# Technical Service BULLETIN

## Title: 4RUNNER BACK DOOR LOCK OPERATION

Models: '96 - '97 4Runner

BODY  
B0004-98

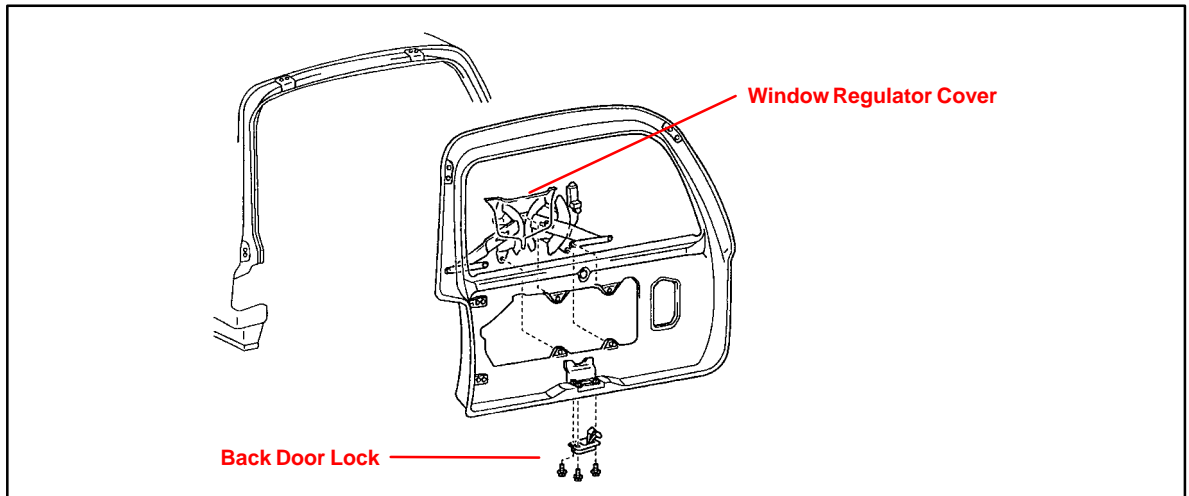
**Introduction** The back door lock mechanism for 1996 and 1997 4Runners has been modified as follows:

- The shape of the window regulator cover has been changed to prevent water from dripping into the back door lock assembly.
- The shape of the back door lock assembly rubber boot has been modified.
- A vinyl cover has been added to the back door lock assembly.

This field-fix requires the upgrade/replacement of the door window regulator cover and the back door lock assembly.

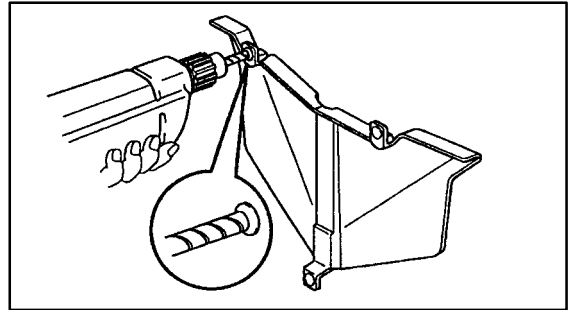
2. Remove the window regulator cover. Using a drill of 4.8 mm (0.189 in.) diameter, cut the flange portion of the 3 rivets.

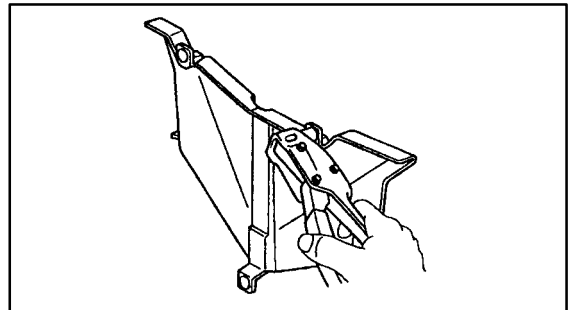
3. Install new window regulator cover. Use a 4.8 – 5.0 mm (0.189 – 0.197 in.) diameter rivet for installation.
4. Install the back door window regulator assembly.

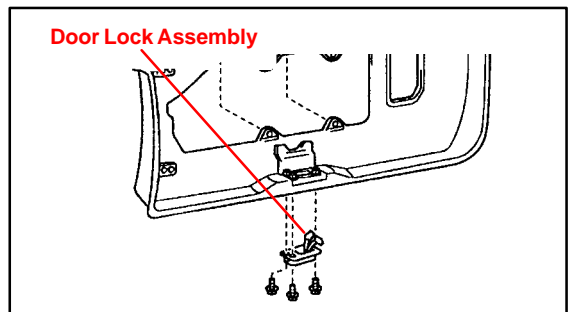
5. Remove the 3 bolts and back door lock assembly.

6. Install the modified back door lock assembly and the 3 bolts.

**Torque: 61 in.lbf (7.0 Nm, 70 kgf.cm)**
